**Planning Commission Meeting Agenda**

Tuesday, January 3, 2023, 5:30 PM

Class C Major Single Family Development Review Staff Report

**Planning Commission Staff Report**

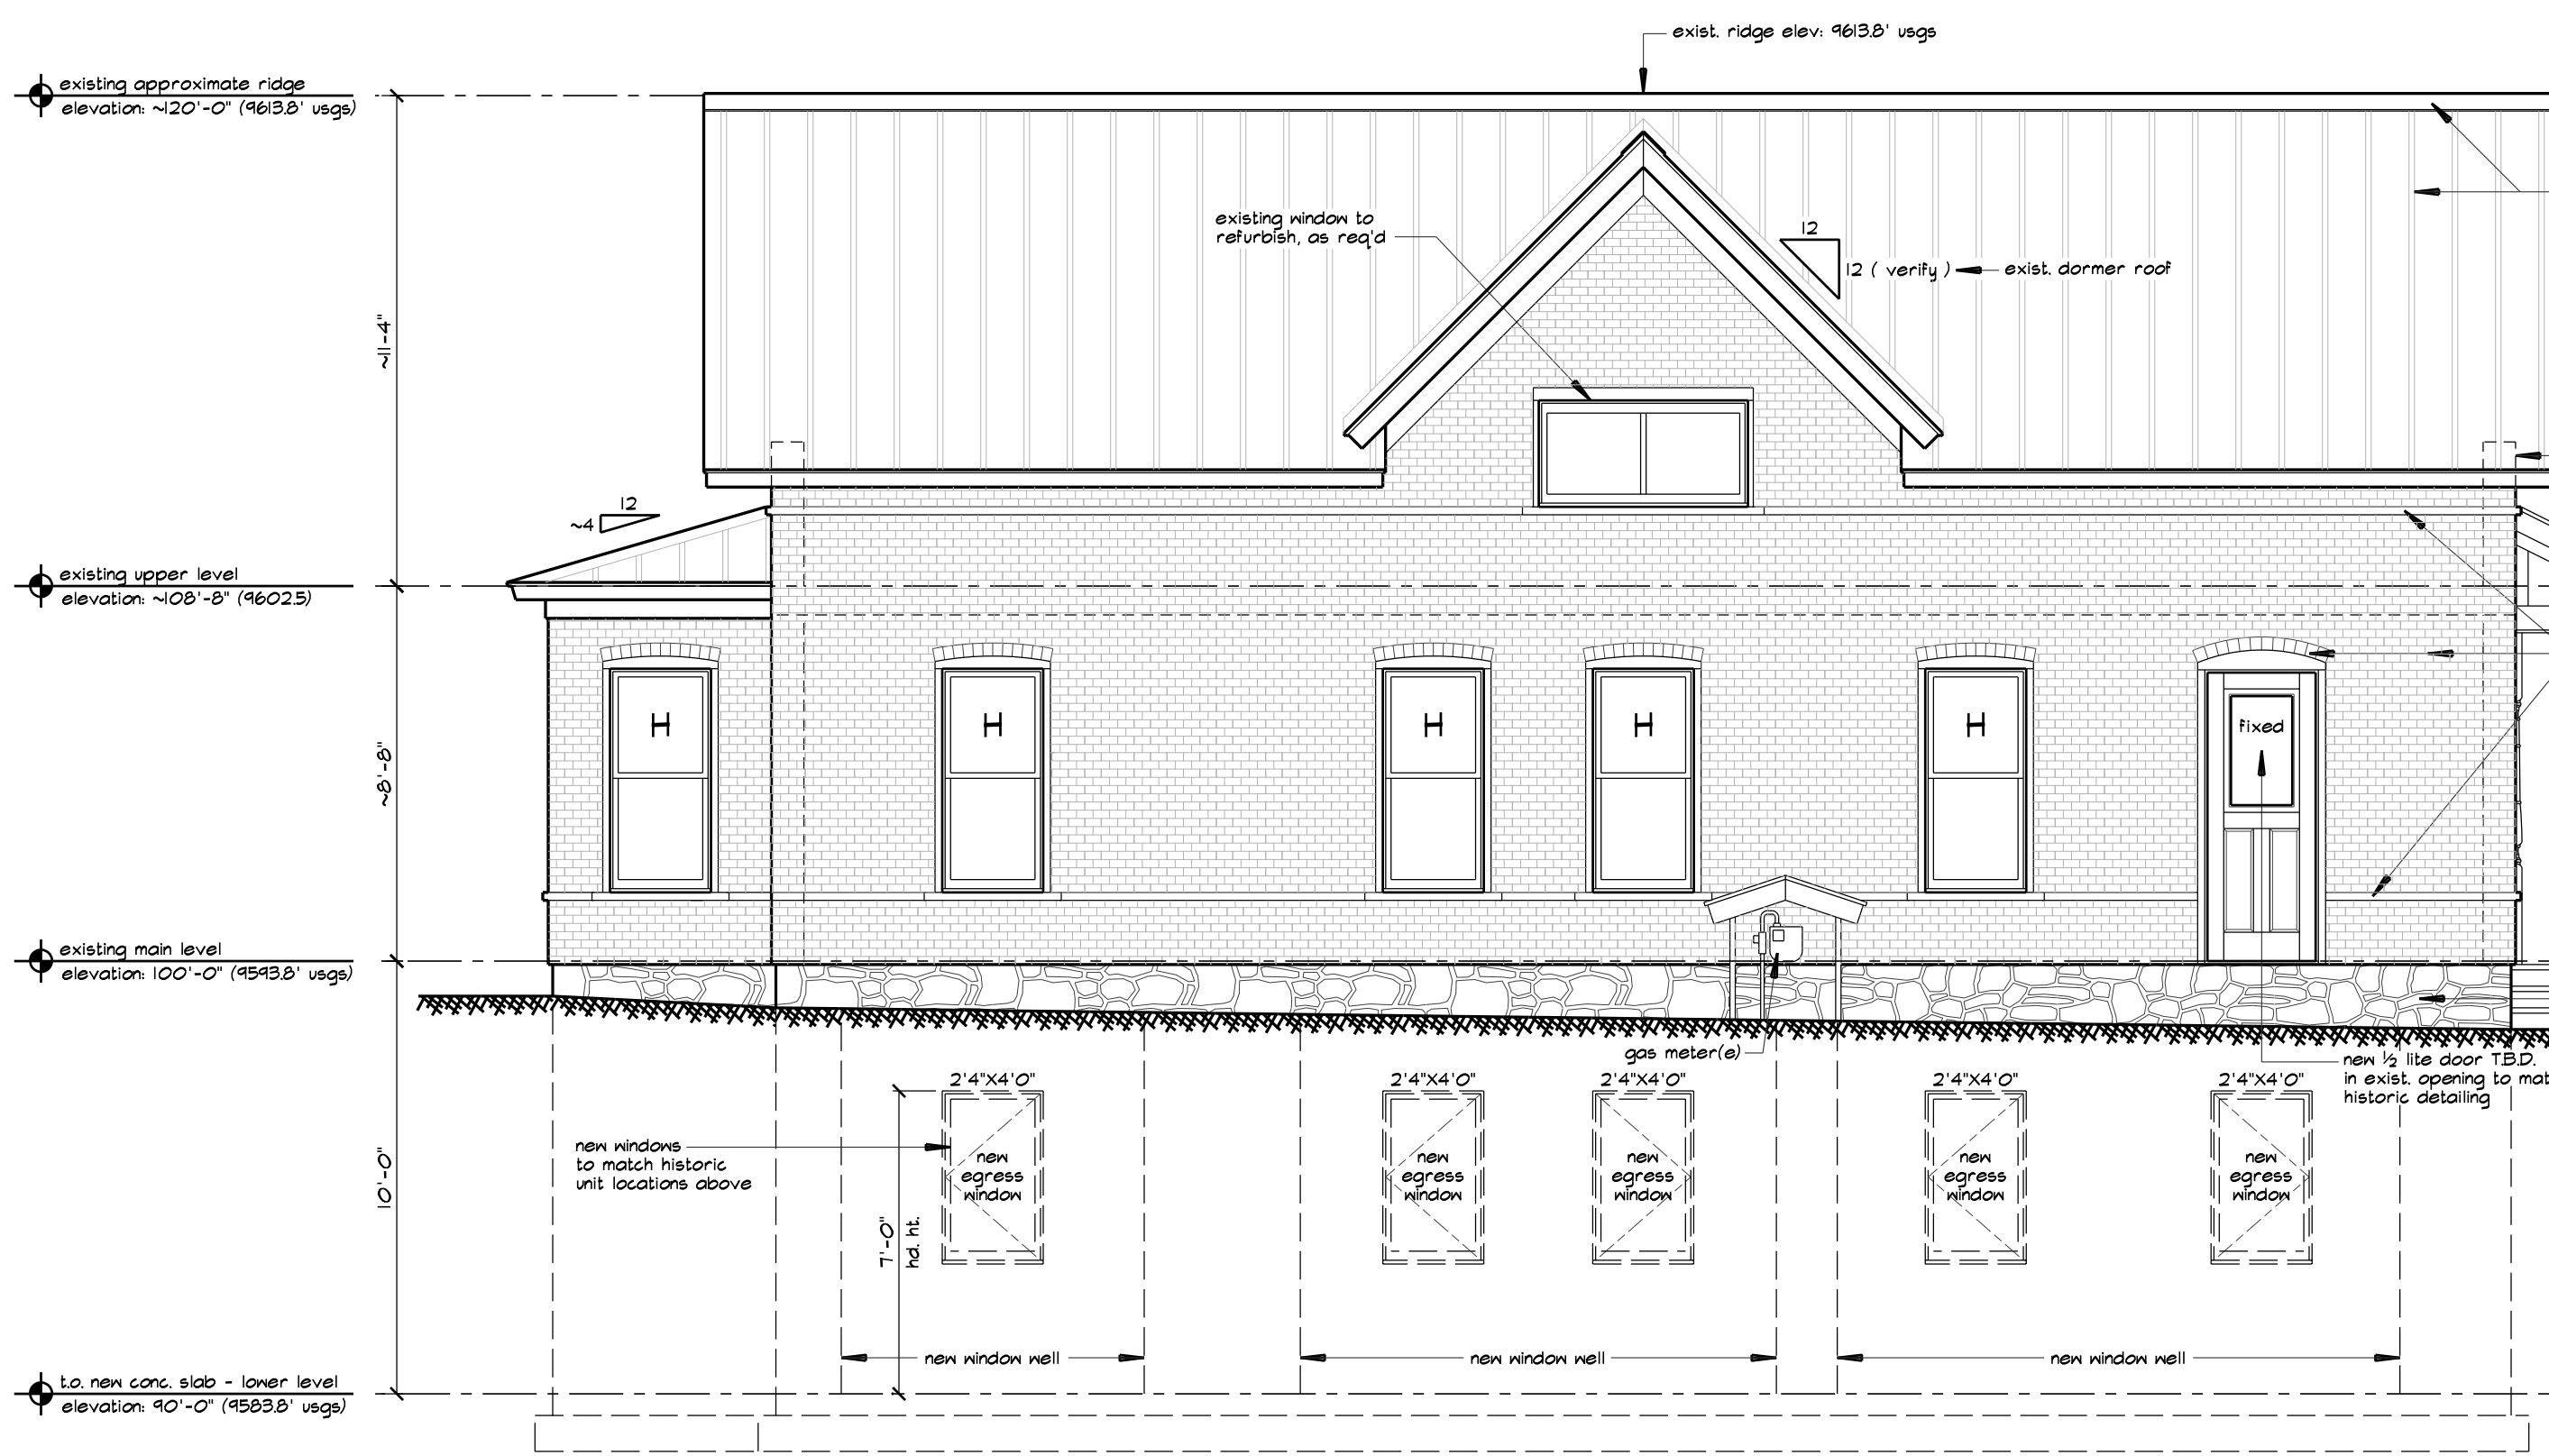
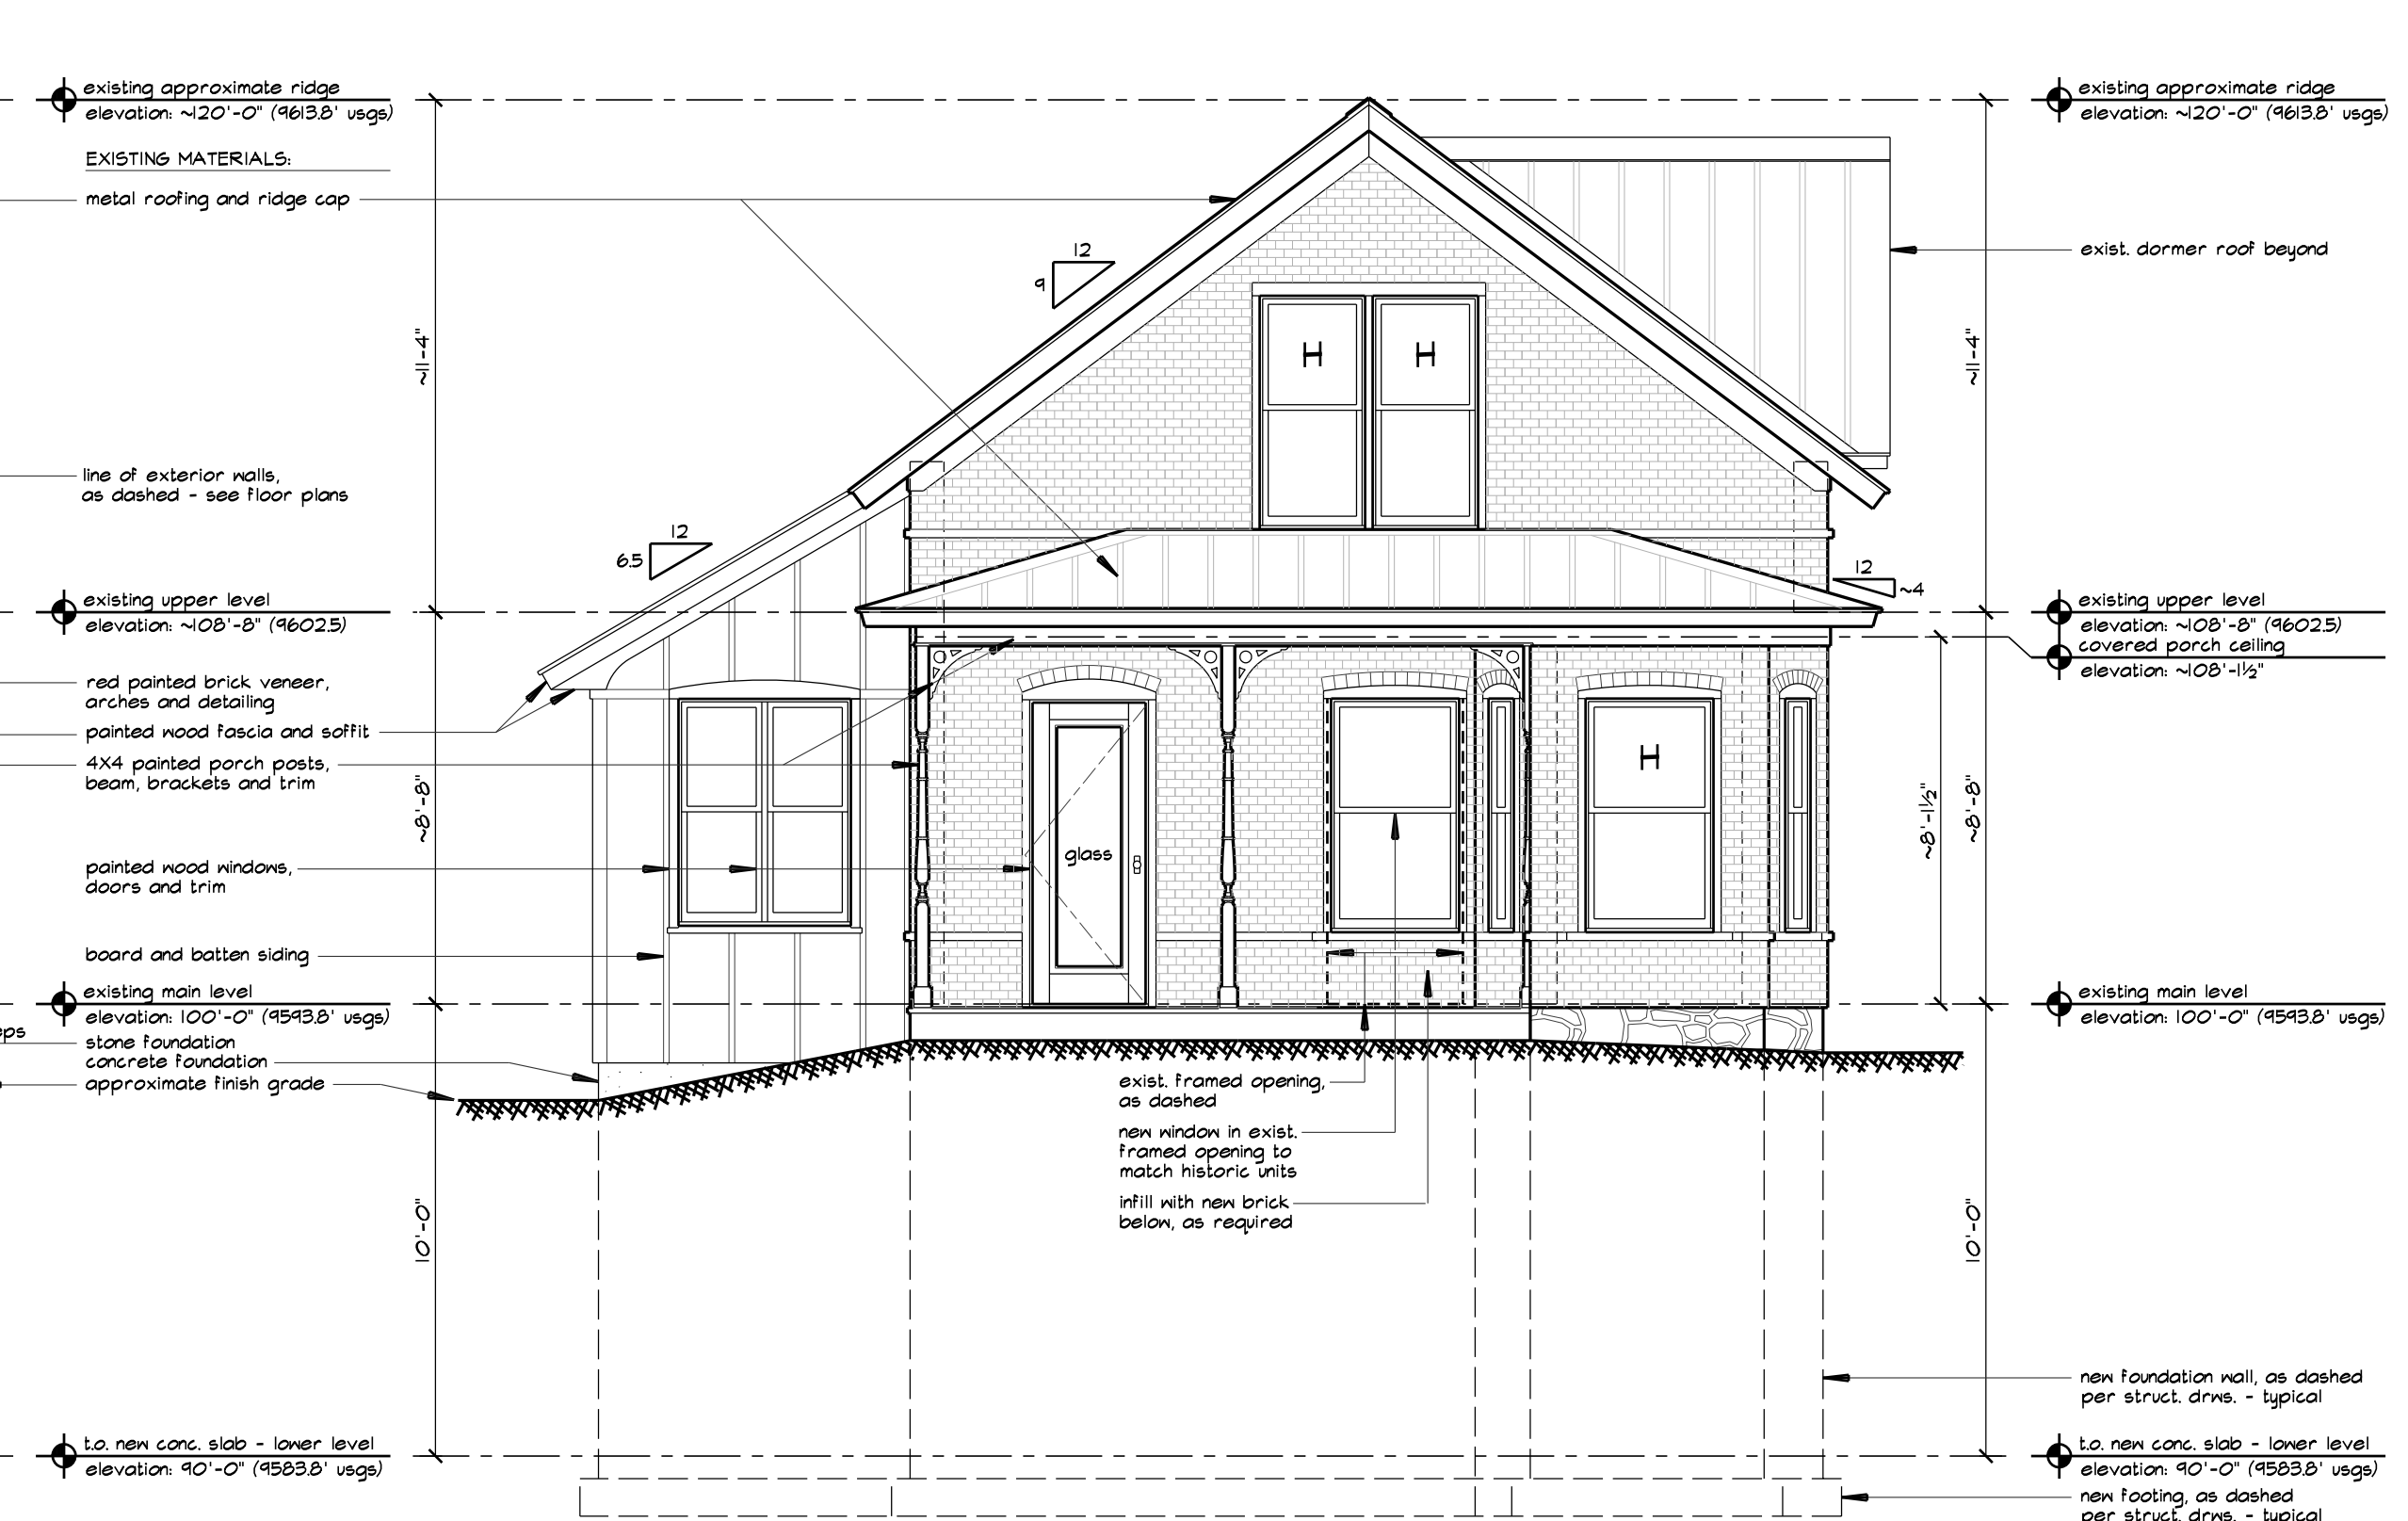
Priority Design Standard 95 states, *“The proportions of window and door openings should be similar to historic buildings in the area”* and that *“this is an important design standard.”* Priority Design Standard 96 further emphasizes the importance of window proportions, *“Use a ratio of solid to void that is similar to those found on historic and supporting buildings.”* Design Standard 91 again reinforces the use of windows that are in a similar size and shape found historically, *“Use building components that are similar in size and shape to those found historically along the street”* and specifically states, *“these include windows, doors and porches.”* The applicant is proposing to reestablish an enclosed door opening on the eastern façade and an enclosed window on the northern façade but would prefer to convert the opening into a space for a double-hung window that matches the other double hung windows on the eastern façade. Staff believes this opening should remain a doorway, does the Commission concur?

The eastern façade’s proposed half-light door is a style that was typical of the character area and the proposed double-hung window will match the other existing double hung windows on the primary historic residence. Staff notes, the sideways double hung window in the upper gable of the eastern façade is original, although it is an odd orientation.
